**For:** Self-Route Expandable Multi-Memory Packet Switch with Distributed Scheduling Means

**Serial Number:** 09/683,429

**Response and Amendment Under 37 C.F.R. §1.111**

FIG. 3

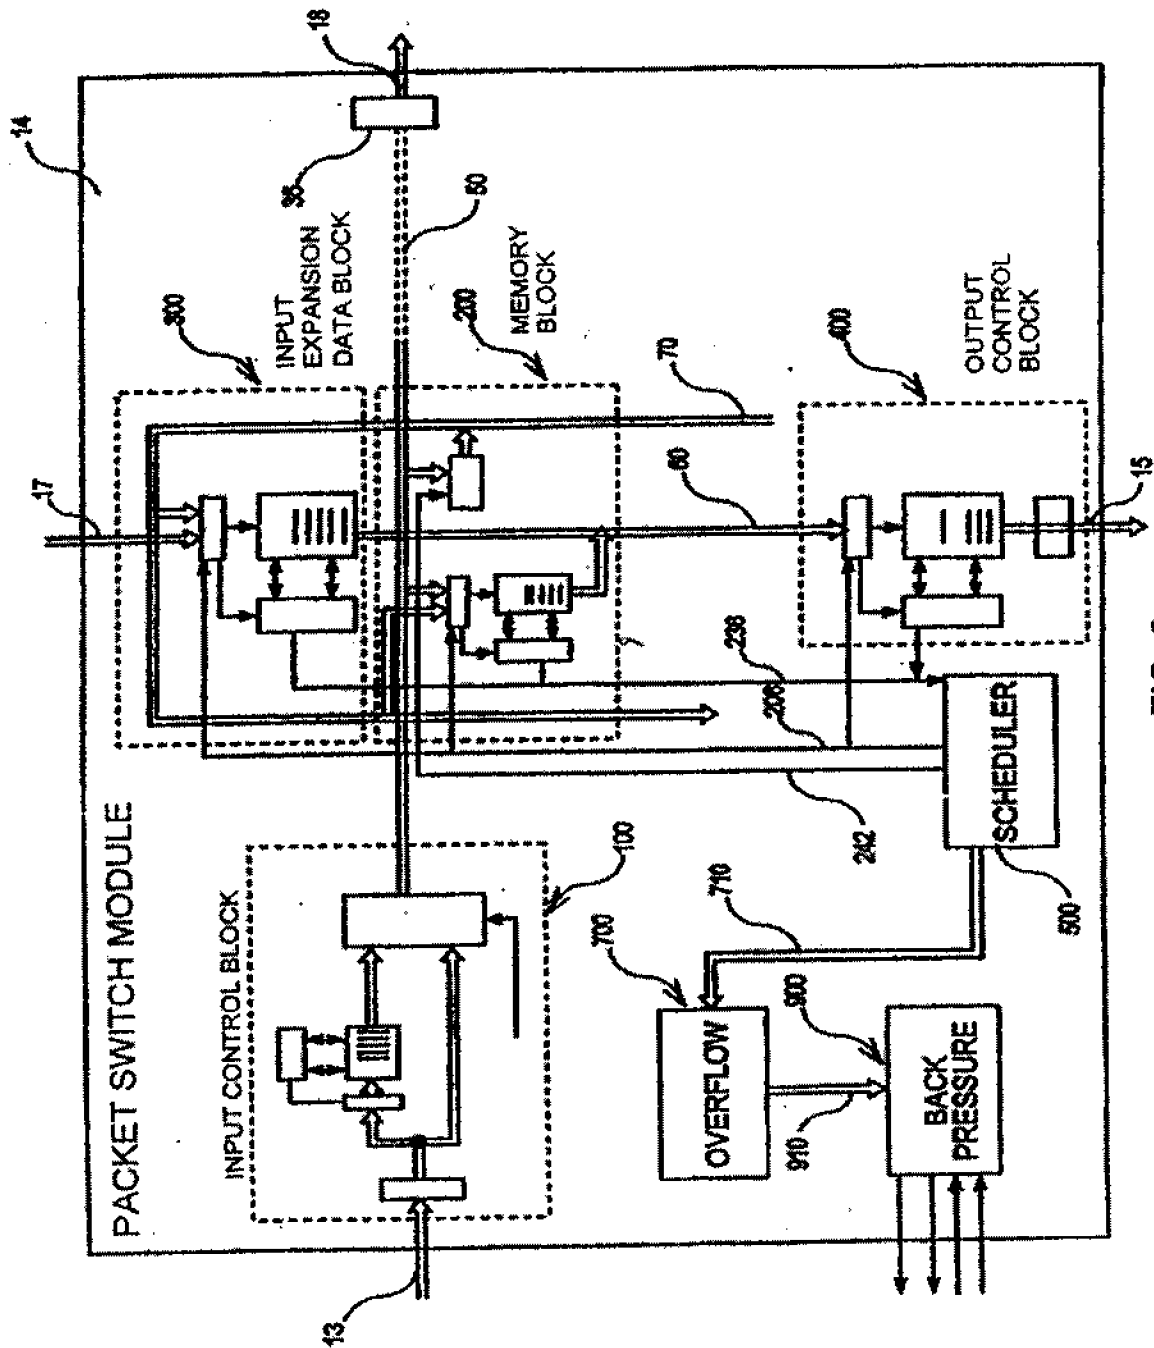
The Office Action stated an objection to Figures 3-8 as failing to comply with 37 CFR 1.121(d) because descriptive labels necessary for understanding the drawings are missing. The Office Action also stated that the quality of the connections shown on Figure 8 is not acceptable. A proposed set of drawings to overcome the objections is attached to this amendment as Appendix A. Each sheet has been labeled "Replacement Sheet" to be in compliance with 37 CFR 1.121(d).

The Office Action stated that claims 1-14 are rejected under 35 U.S.C. 112, second paragraph as being indefinite for failing to particularly point out and distinctly claim the subject matter which applicant regards as his invention. Specifically, for Claim 1, the Office Action stated that it was unclear as to what output and input ports are considered a pair and what is the definition of a cross point. Applicants submit that the definition of “cross point” is defined in paragraph 10 of the specification as “each couple of an input port and an output port defining a cross point within the switch module” and is shown in Figures 1, 3, 5, and 8. In Figure 1, the input and output ports are shown as the input buses 13\_1 – 13\_4 and corresponding output busses 15\_1 – 15\_4 coupled

to the packet switch module 14. A pair is therefore any one of the input ports (i.e. input bus 13) coupled to any one of the output ports (i.e. output bus 15). For example, one cross point is input bus 13\_1 coupled to output bus 15\_4, or input bus 13\_2 coupled to output bus 15\_3, etc. Thus, for 4 input ports and 4 output ports there is a total of 16 cross points. In Figure 3 the cross point is shown as the intersection of elements 50 and 60, which are coupled to data bus in 13 and data bus out 15 respectively (see paragraph 27). Memory Block 200 is associated with the cross point shown in Figure 3. Figure 5 shows a block diagram of Memory Block 200 with the intersection of elements 50 and 60 showing the cross point. Figure 8 shows multiple cross points for input ports 13\_1 – 13\_m and output ports 15\_1 – 15\_m and represents an mxm number of cross points with associated memory blocks 200 for each cross point.

each memory block associated with one of said cross points ...”. Support for Applicants’ claim 1, as amended, can be found, for example, in paragraph 0025 and Figure 3.
